SUBJECT: Drag Brace Weld Clearance Inspection

APPLICATION: All Glasair III aircraft prior to kit number 3295.

MODEL	ASSEMBLY NAME	REVISION	DATE	VOLUME	PAGE
GLASAIR III	SERVICE BULLETIN 129		1/10/95		1 of 2

FIGURE (1)

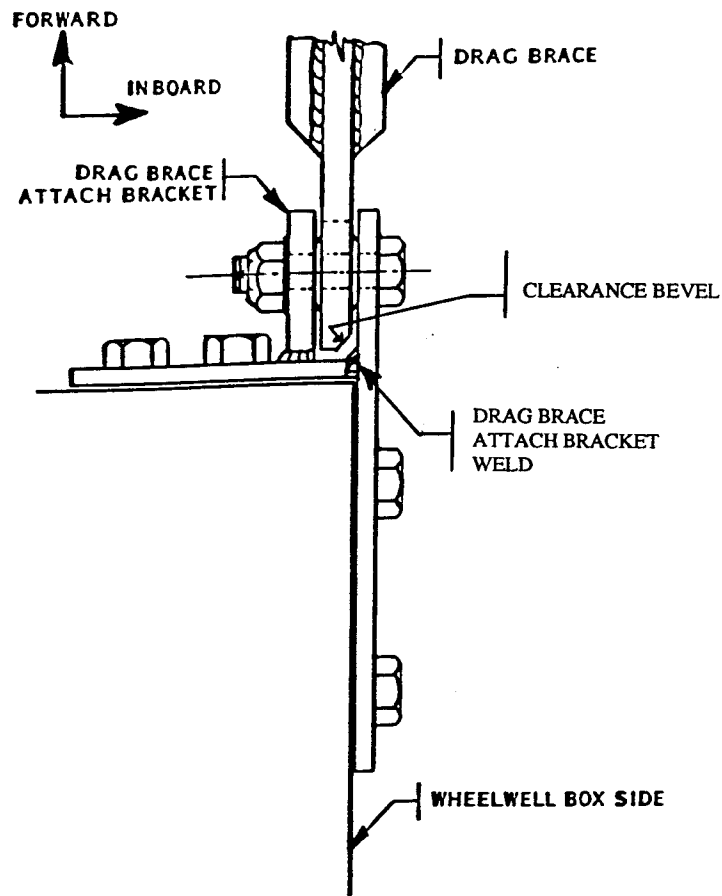
DESCRIPTION: Some Glasair III nose gear drag braces (363-5410-101) may have been fabricated without proper clearance bevels. The bevels provide clearance between the aft edges of the drag brace arms and the welds on the drag brace attach brackets, as shown in FIGURE (1). Improper clearance can cause additional friction during gear operation and may effect proper retraction or extension of the nose gear.

REQUIRED ACTION: A one-time inspection is required to verify that the drag brace incorporates the bevels. The inspection is easily done even if the drag brace has been installed on the airplane. Visually confirm that the aft edge of the drag brace has a minimum of 1/16" clearance from the weld, as shown in FIGURE (1), throughout the entire range of travel of the drag brace.

FIGURE (2)

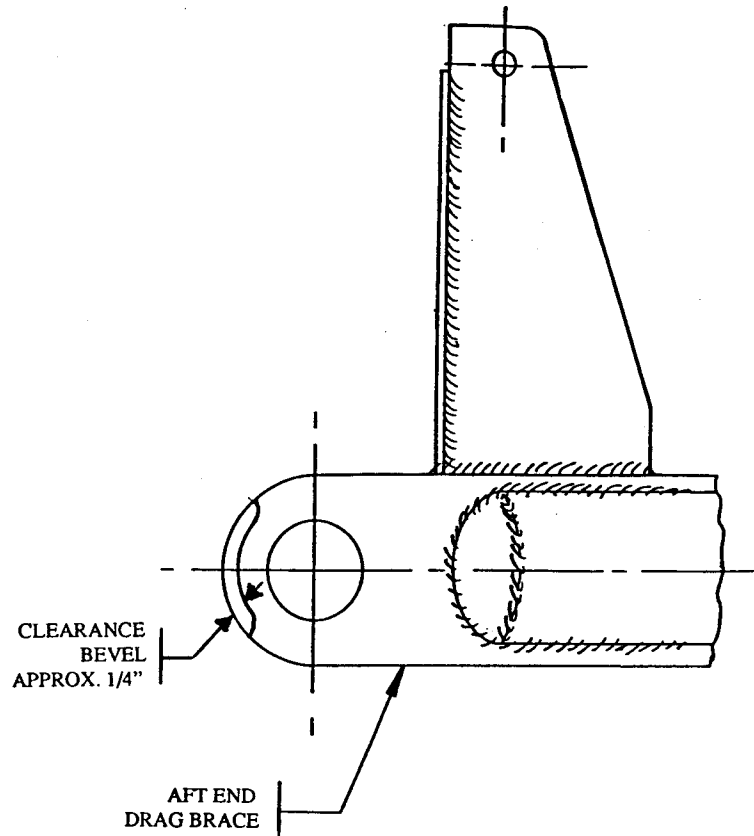
MODIFICATION PROCEDURE (if required):

The drag brace must be removed from the aircraft and bevels trimmed onto its aft ends, as shown in FIGURE (2). This will require jacking the aircraft. The bevel can be cut using a file or a disc sander. Use a fine tooth file to smooth out the bevel after proper clearance has been achieved. Prime the exposed bare metal with an epoxy primer and touch it up with a white paint if desired.

Reinstall the drag brace and verify that the bevel provides adequate clearance from the weld.
